LEVEL 3 & 4 DEVELOPMENT REVIEW APPLICATION

Level 4 Review

Stuart Property

Thornhill Road

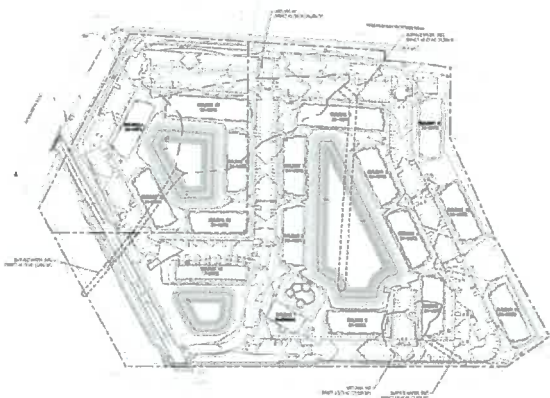
Bubble Plan - The bubble plan shows a proposed Residential-High (RH) designation, but the application states that the request is for Residential-Medium (RM). Please clarify.

RESPONSE: The application was in error. The proposed bubble plan is correct as shown.

Results

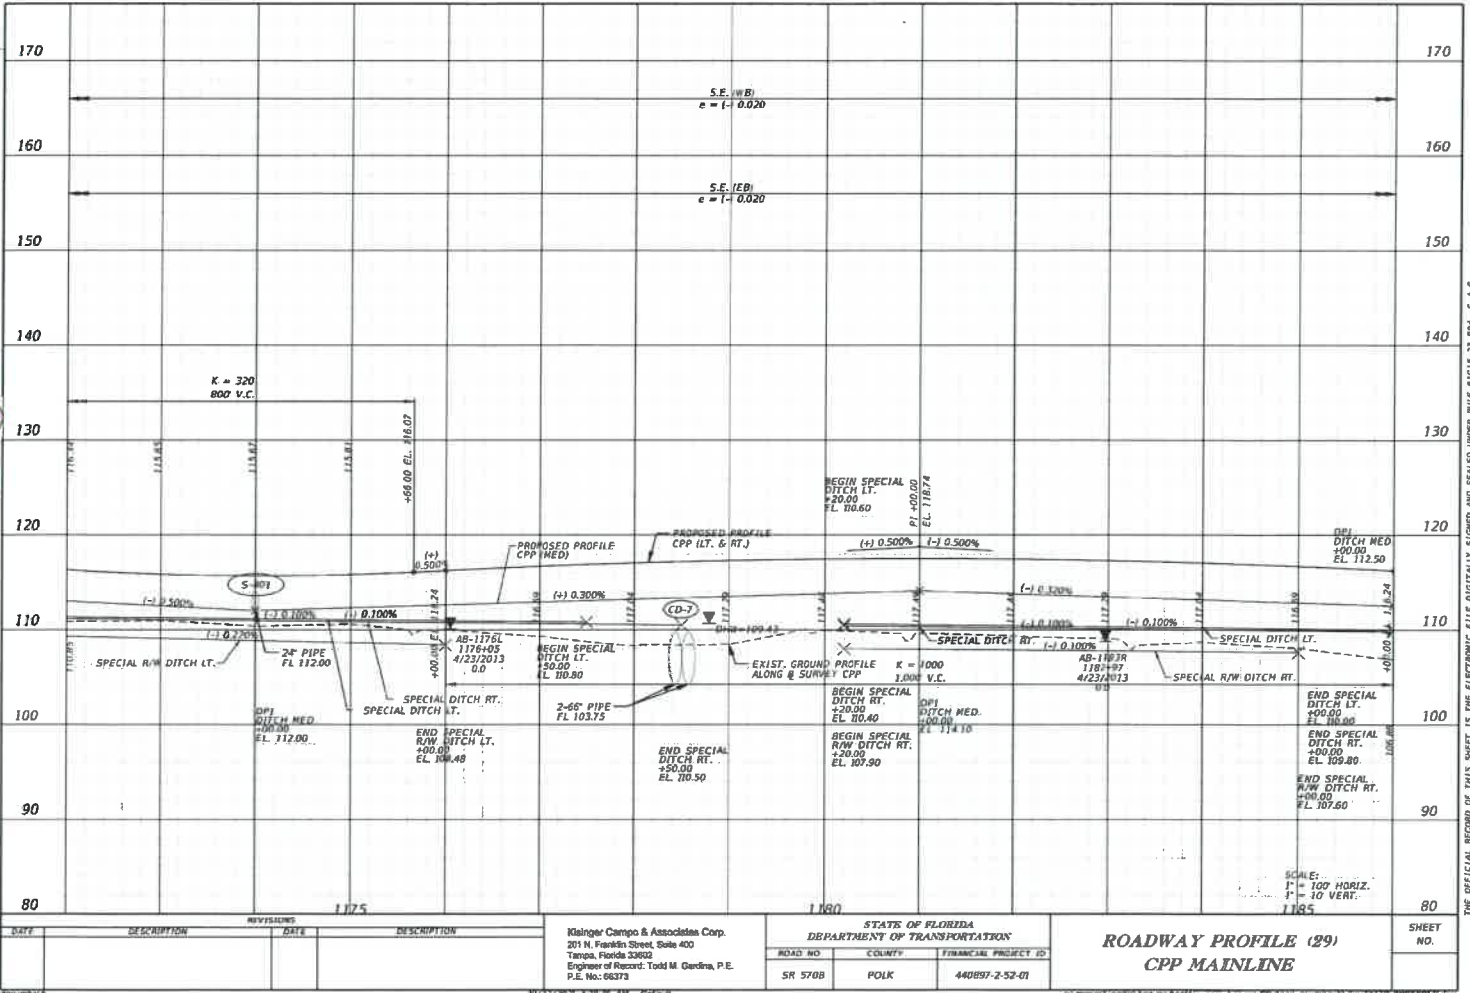
Airport Impact District - According to the Airport Impact District Map, the subject property appears to be in the height notification zone and the in-flight visual interference zone for the Bartow Municipal Airport. Please provide a narrative on the proposed use will impact the airport (if applicable).

RESPONSE: The FAA OEAAA website to evaluate potential 5-story apartment building which would be under 75 ft in height. Using the average site elevation with 75 ft the FAA site states Notice Criteria was not exceeded (see provided print out document). . At time of development, the developer would coordinate with the FAA and Bartow Airport. It is also likely an aviation easement would be required to be recorded as part of the development.

ROADWAY PLAN (20)
STA. 1158+00 TO STA. 1172+00

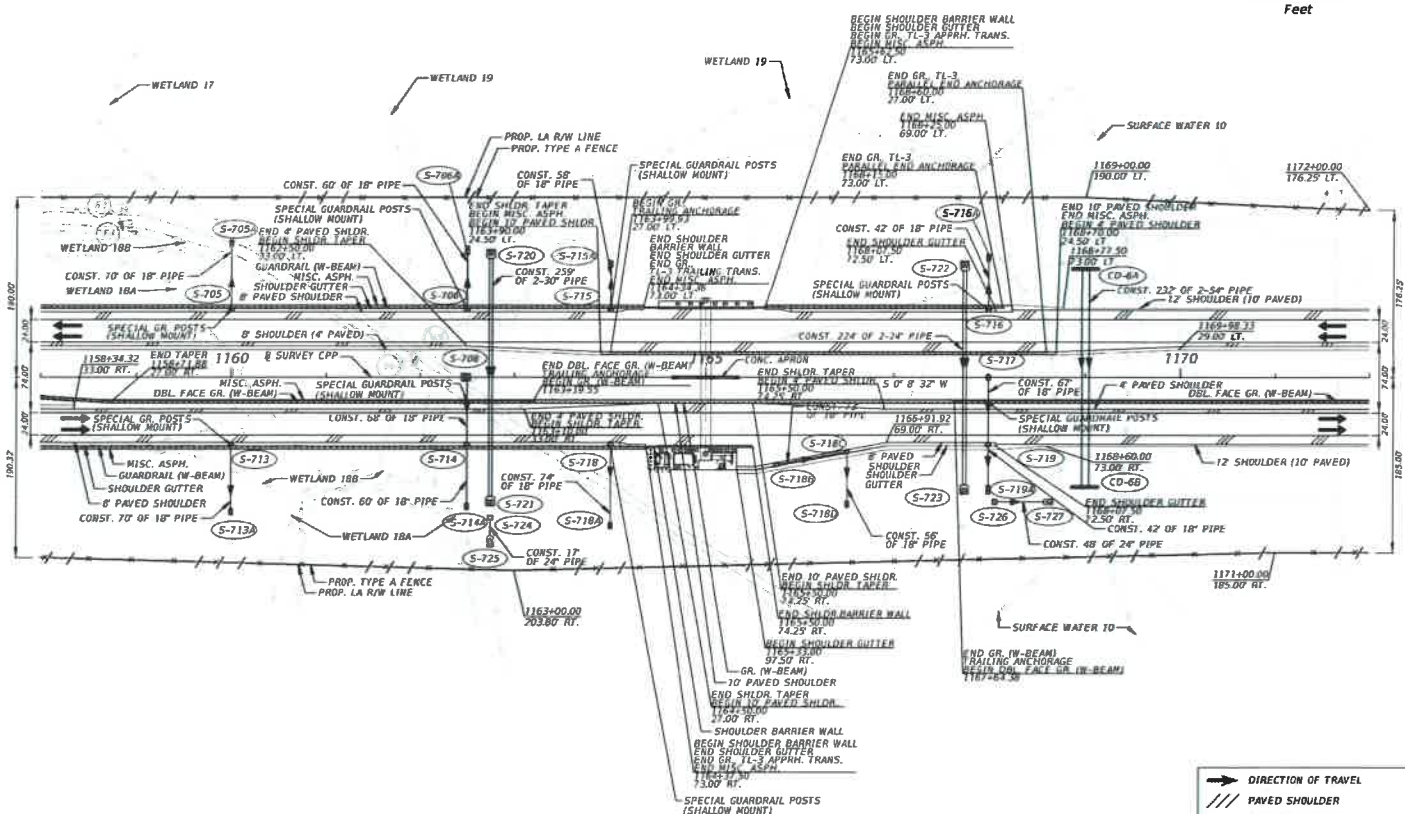
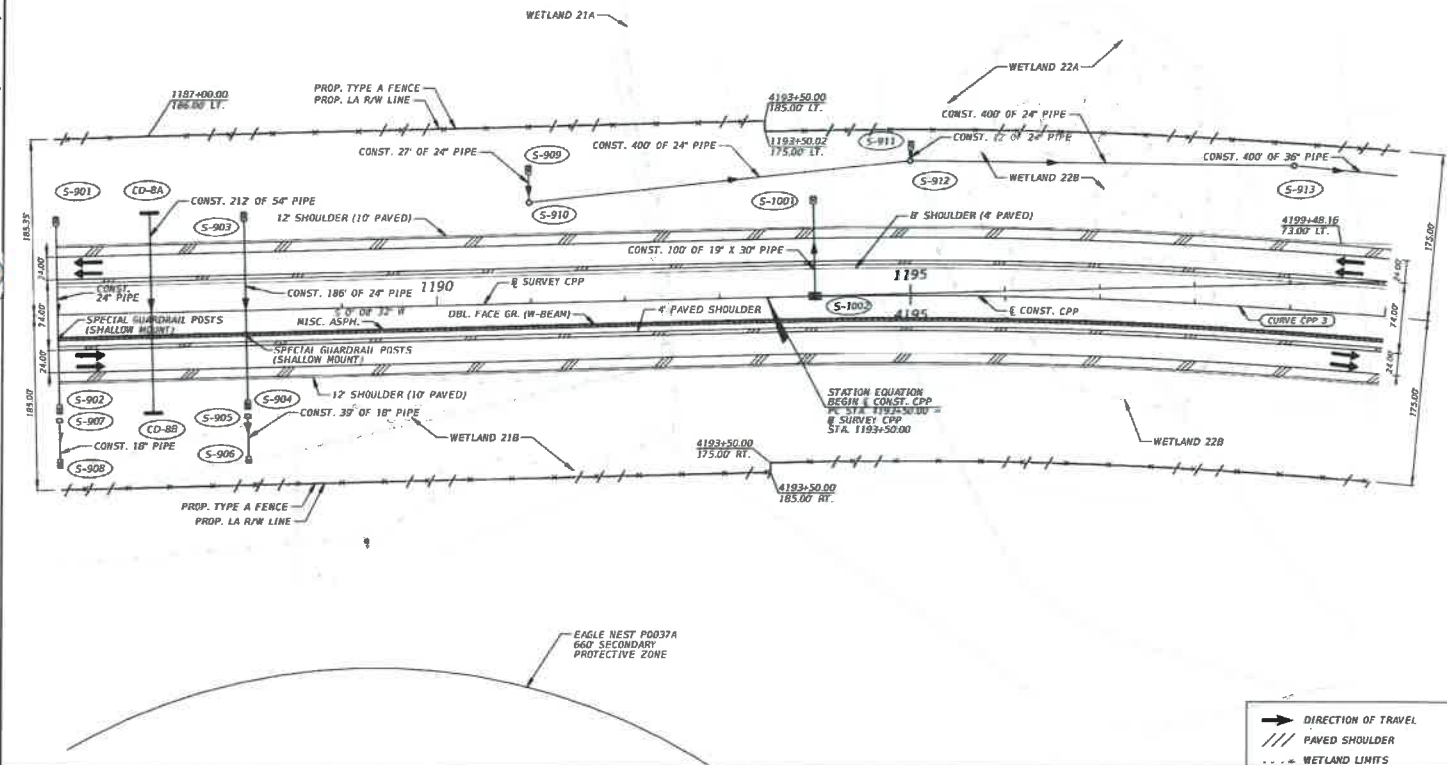
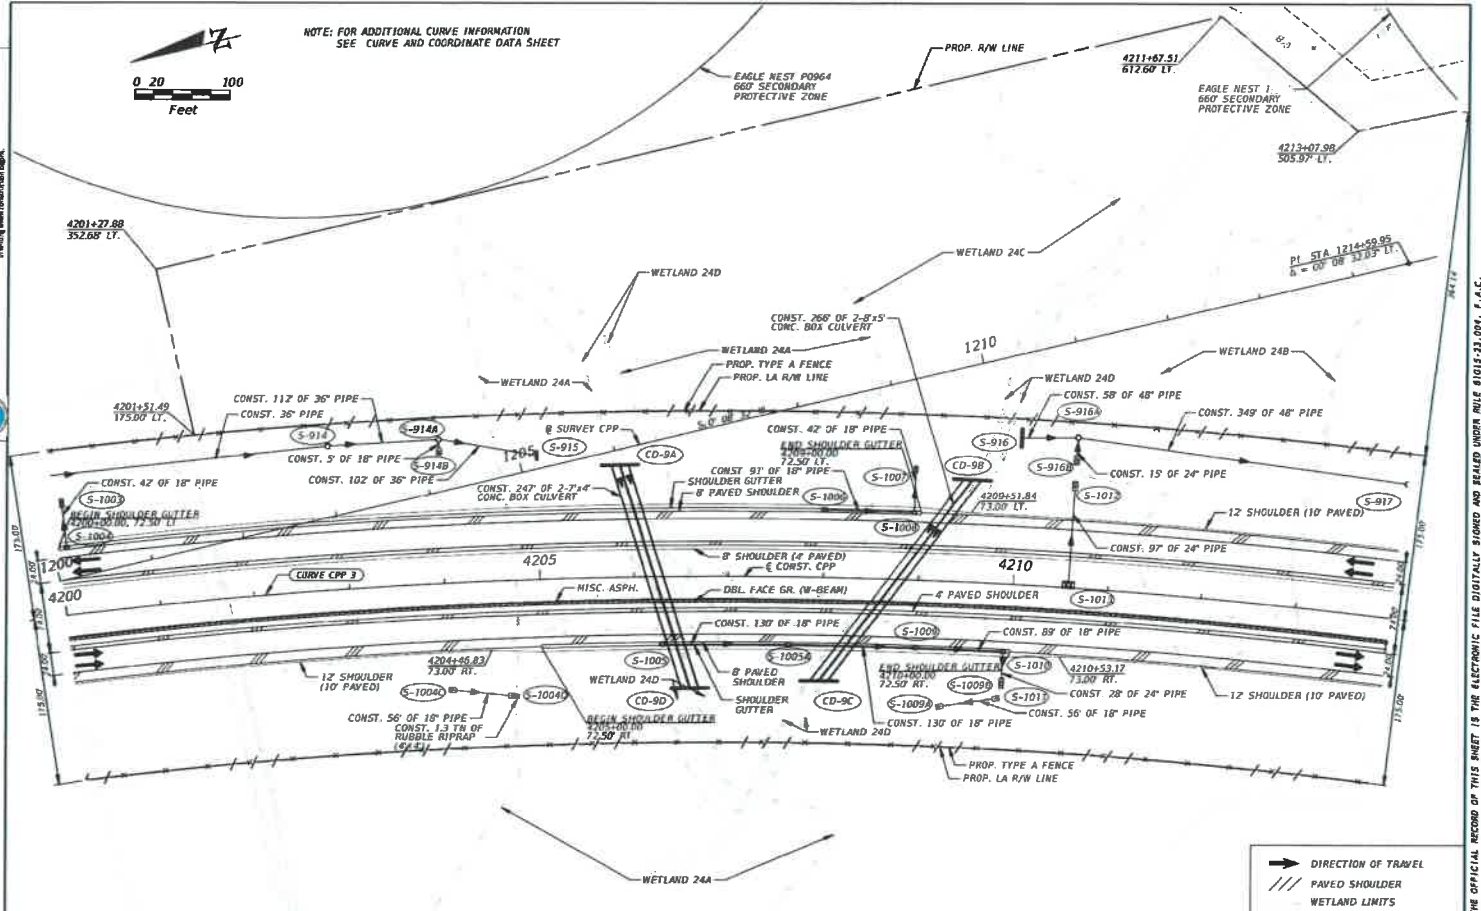
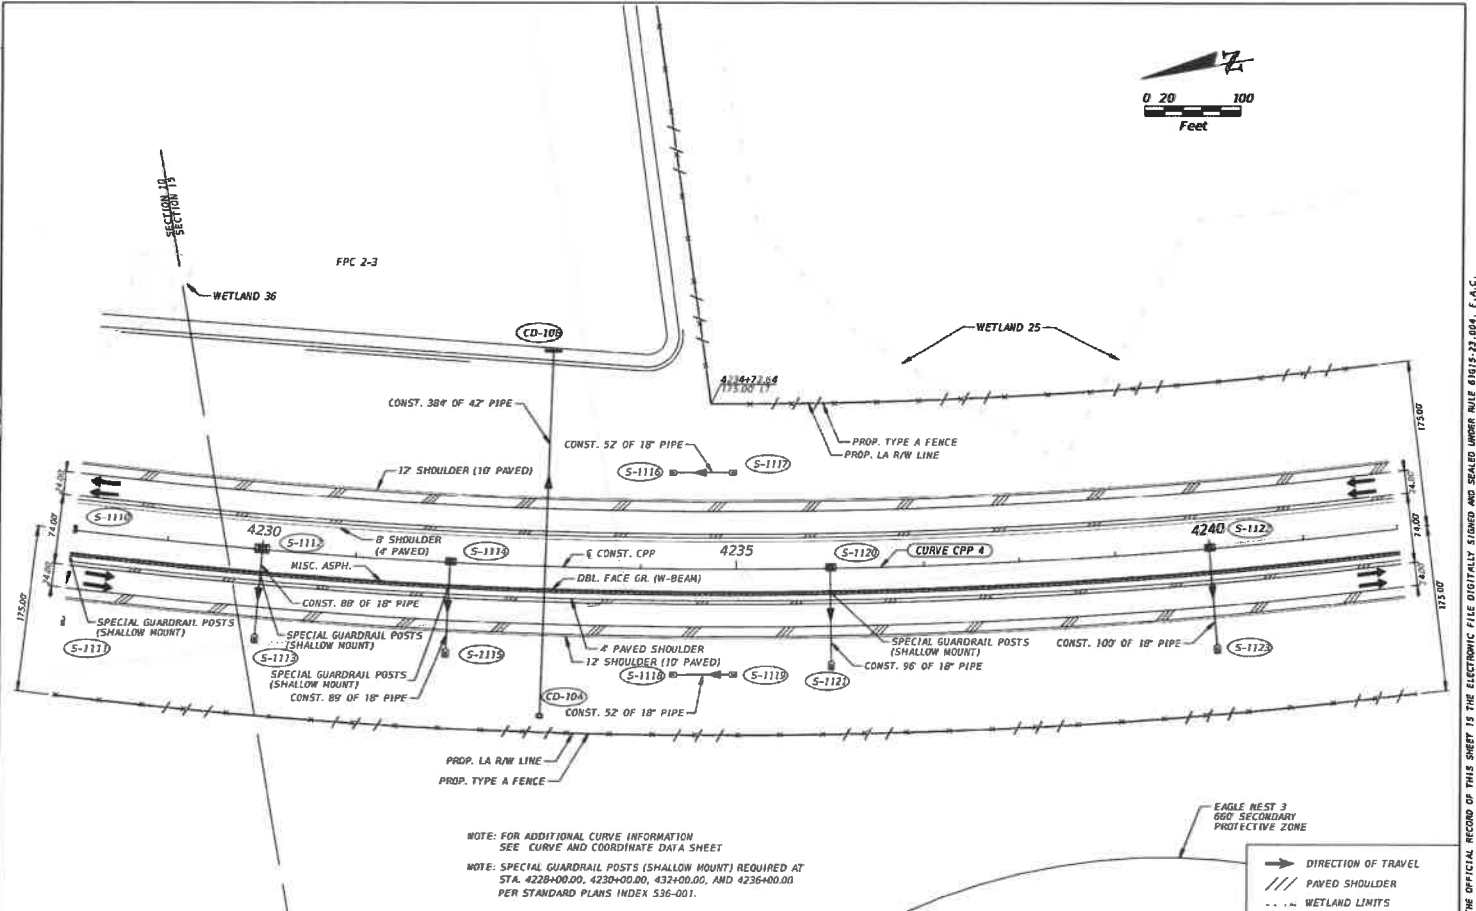
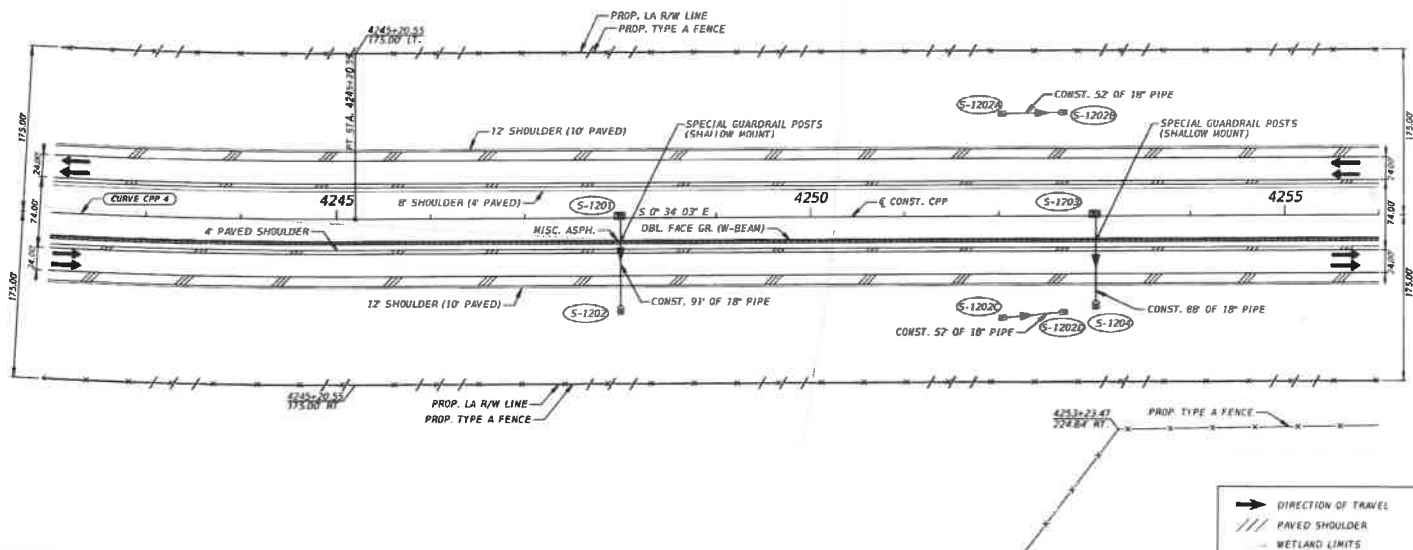
Parkway/Thornhill Road - The Impact Assessment Statement mentions that the Polk Parkway extension will include elevated overpasses with Mechanically Stabilized Earthwalls. Will the Polk Parkway have an interchange with Thornhill Road? Will vehicles on Thornhill Road be also to access the parkway at this location? Please provide cross-sections, sketches, etc. showing the wall

RESPONSE: No interchange is planned. Plans sheets and roadway profile sheets for this area have been pulled from readily available online documents and provided with our response. The construction of the Polk Parkway Extension as a limited access arterial road materially changes the character of the subject property. The property's location proximate to the expanded interchange at Winter Lake Road provides increased access to other regions in the area, which makes the site ideal for residential development at urban densities. As shown below, it is common in Polk County for development to occur around newly expanded infrastructure. This can also be shown along turnpike facilities(SR 429/SR 417) in nearby areas.
